7-2. MONITORING WELLS BETWEEN LUE AND SITE

Concern:

Figure 1: Monitoring near Lue (Bowdens Silver, 2020)

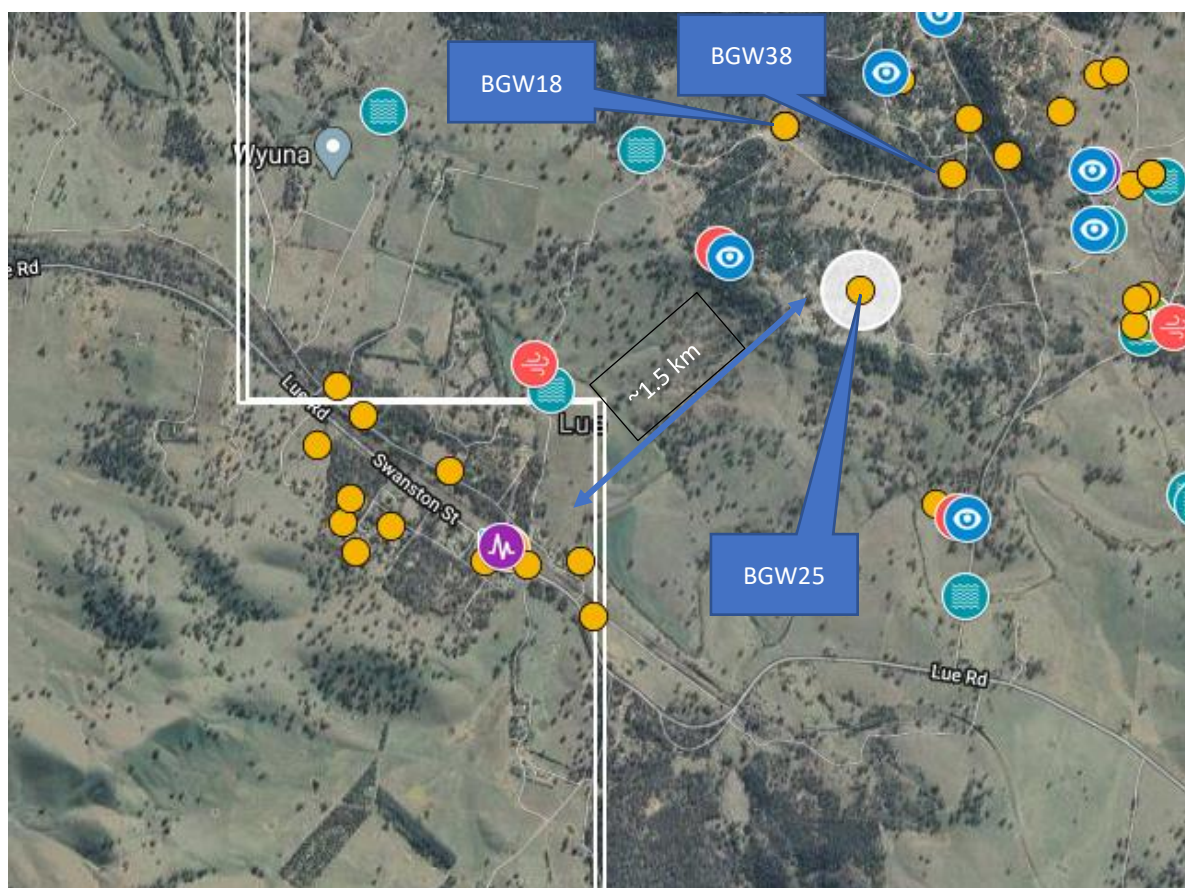
To understand the groundwater impact to the Lue village area, groundwater investigation bores are required. None have been drilled over the 1.5 km separating the site from Lawsons creek near the village

No investigation or monitoring bores have been drilled between those close to the site (BGW18, 38, etc) and Lue (Bowdens Silver, 2020) shown as Figure 2. Over this 1.5 km distance (Figure 1), EIS modelling has predicted a 1 m drawdown in the water level in (and presumably under) Lawsons creek near the Lue Village. The lack of investigation wells in the 1.5 km between the pit and Lue does not enable a solid understanding of the hydraulic connectivity between the proposed pit and Lue.

Figure 2: Wells tested for hydraulic aquifer properties are to the northeast of the red line – Figure 23 in (Bowdens Silver, 2020, pp. 5-88)

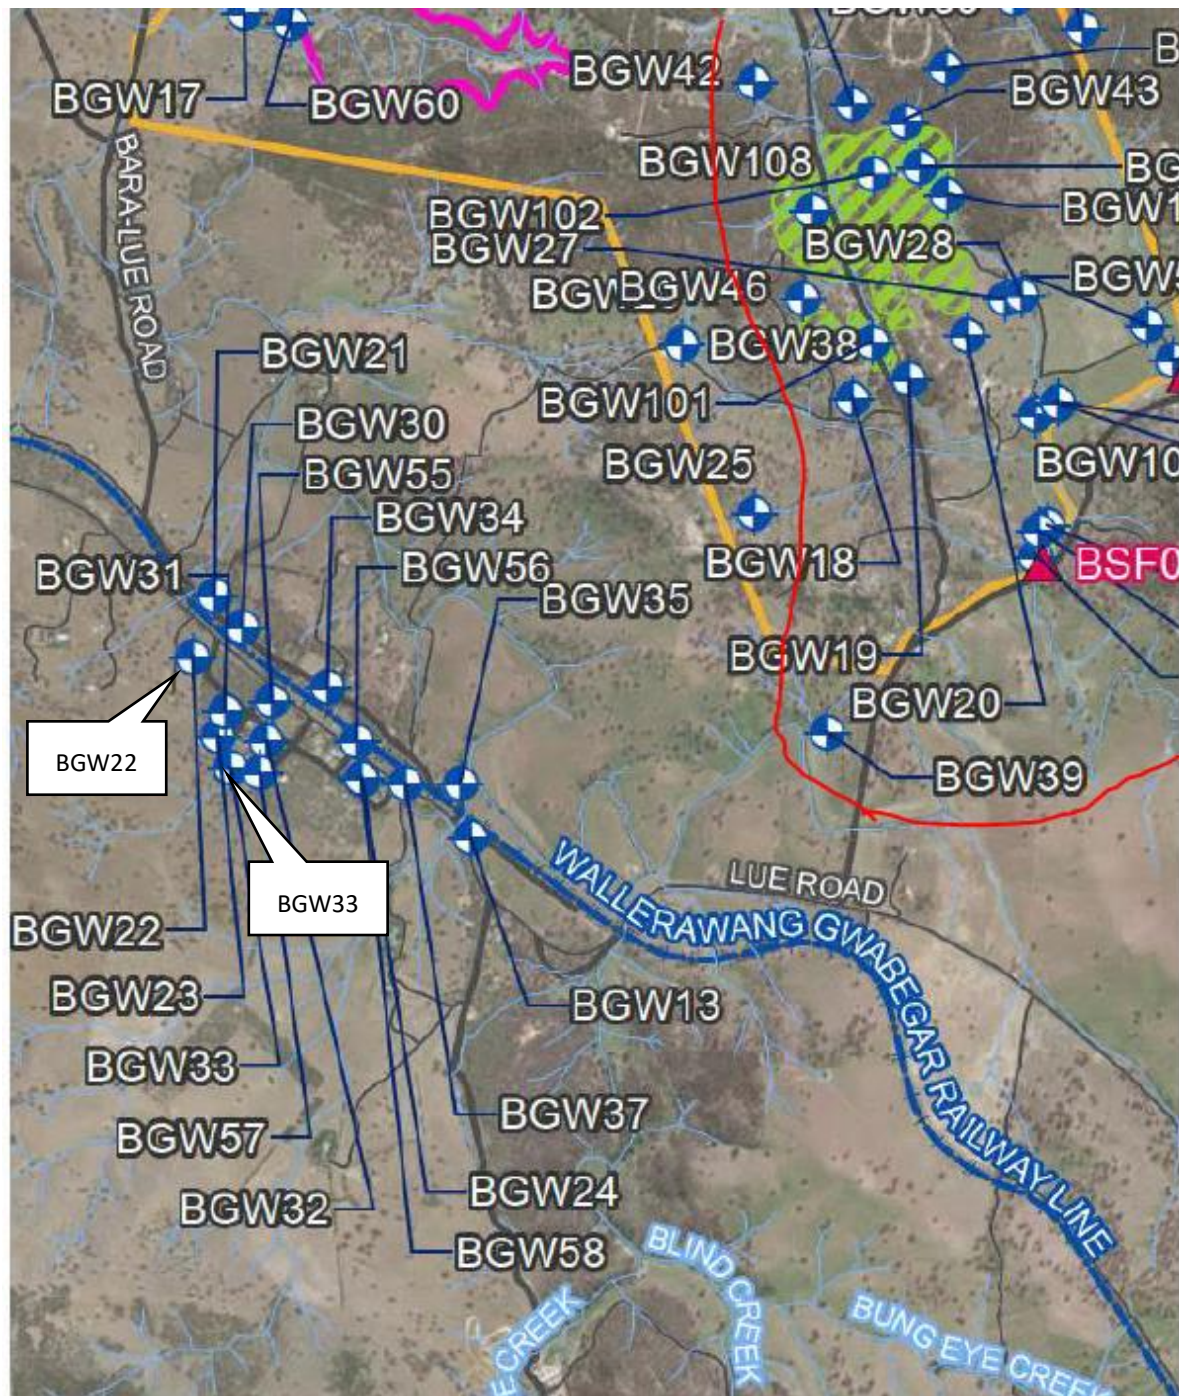
1. Aquifer properties – derived from data northeast of the red line in Figure 2
2. Groundwater quality - tested from 6 samples in Lue Village out of 60 samples across the site
3. Groundwater levels monitored in the wells shown in Figure 3

Figure 3: Groundwater hydrographs, showing difference in water level response in BGW22 & BGW33 shown in Figure 1. Source: Figure 25b of (Jacobs (Australia), 2020, pp. 5-91)

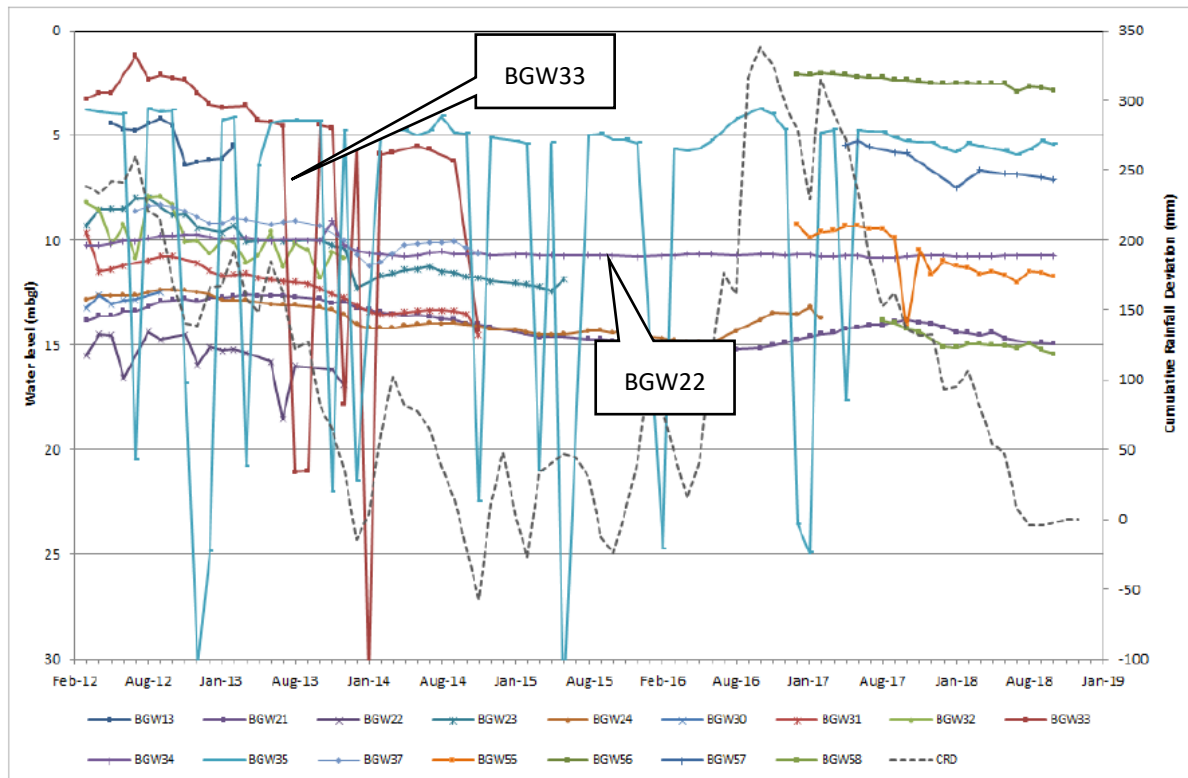
It is not clear from the information provided in the EIS what time period the groundwater contours reflect. Given that there can be groundwater level variations of up to 10 m in some wells (Figure 3 and Figure 4), it is important to define a particular period from which to generate the contours to accurately represent the flow field.

Figure 4: BGW39 groundwater hydrograph. Source modified from Figure 26b (Jacobs (Australia), 2020, pp. 5-93)

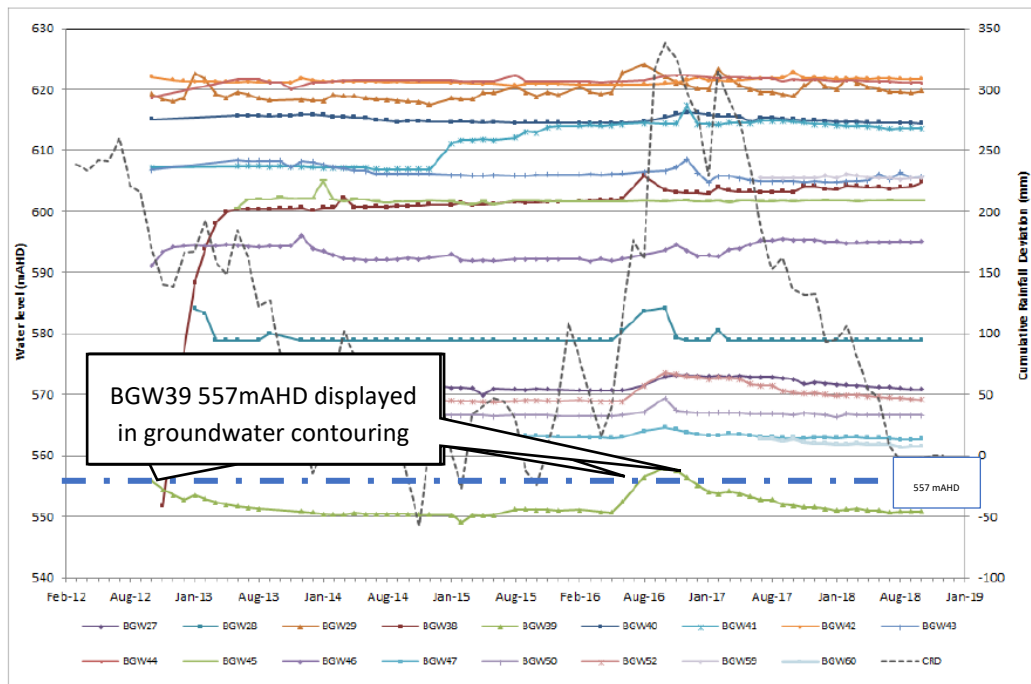
For example, the EIS does not explain why the 557 m AHD groundwater level was used for well BGW39 as opposed to a level of around 550 m.

Figure 5: Groundwater contour map inferring groundwater flow direction

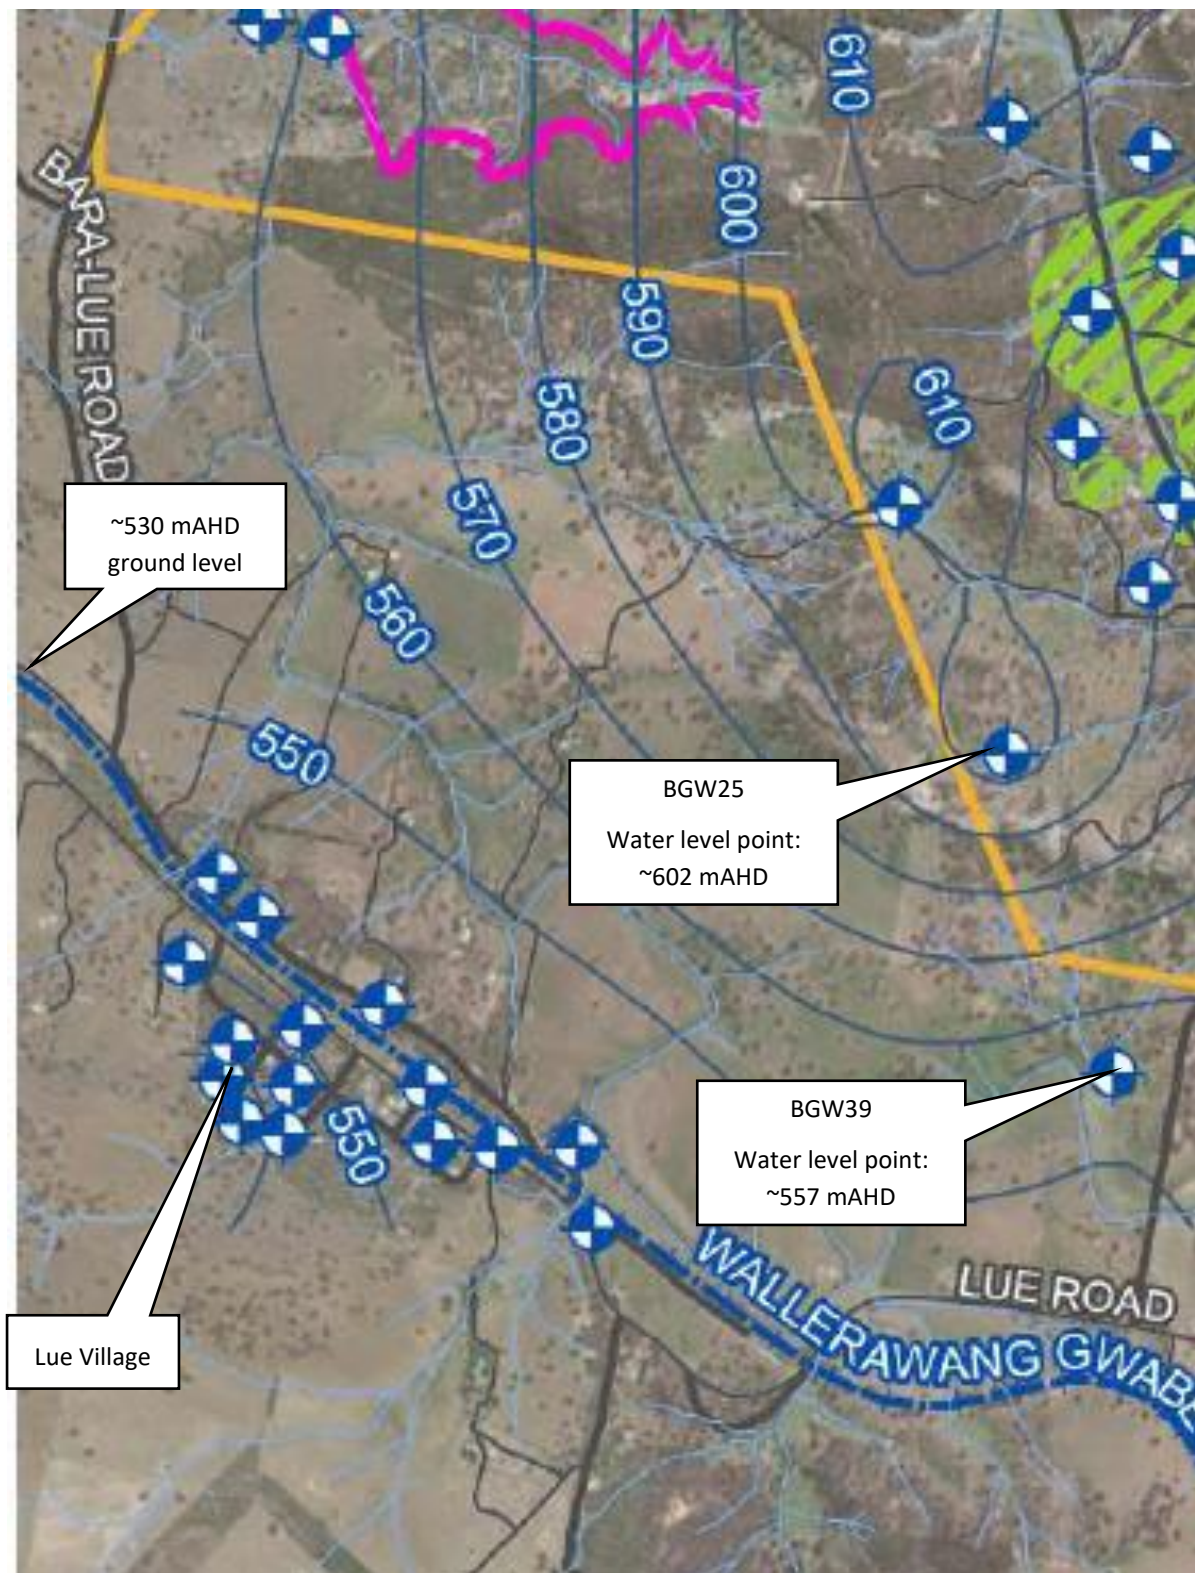
Inspection of Figure 26a of (Jacobs (Australia), 2020, pp. 5-92) shows that data for neighbouring monitoring well BGW25 was only taken from July 2013 to July 2015 – dates that do not align with the available data for BGW39. While the groundwater levels are, for some reason, not plotted in

mAHD on Figure 26a, using a ground elevation of 630 mAHD, the water level elevation can be estimated at 577 mAHD. This is 25 m lower than the contouring presented in Figure 5. This unexplained uncertainty in groundwater level contouring could be addressed if investigation and monitoring wells were installed between the site and the Lue Village.

Figure 6: Provenance of hydraulic conductivity (does not approach Lue Village) from Figure 17 (Jacobs (Australia), 2020, pp. 5-74).

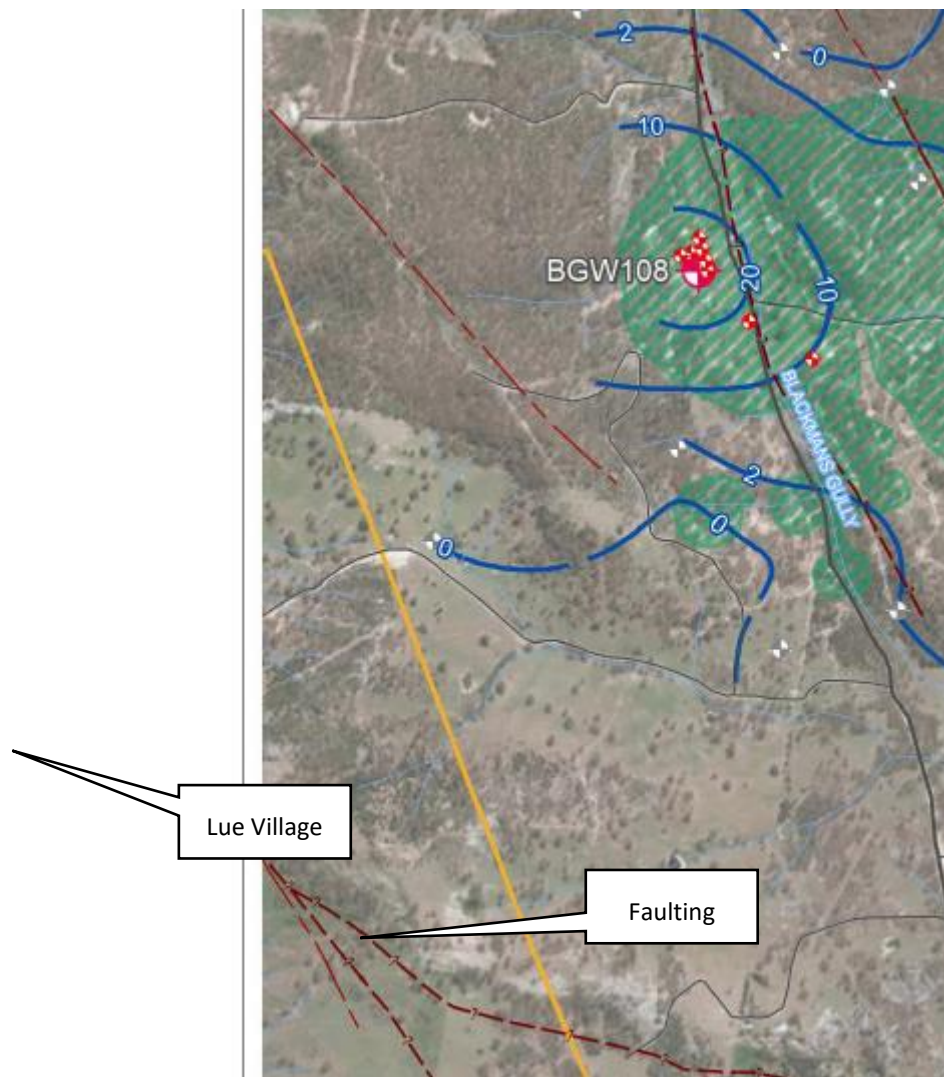
Importantly, a well on the site (GW802779, 500 m south east of the proposed pit) reported a yield of 20 L/s in the fractured Coomber Formation. A southwest to northeast cross section, if presented, would have shown that the Coomber formation is likely continuous between GW802779 and Lawsons Creek near Lue. The groundwater contouring in Figure 6 shows data gaps to the west. The lack of investigation wells between the pit and Lue does not enable a solid understanding of the hydraulic connectivity between the proposed pit and Lue.
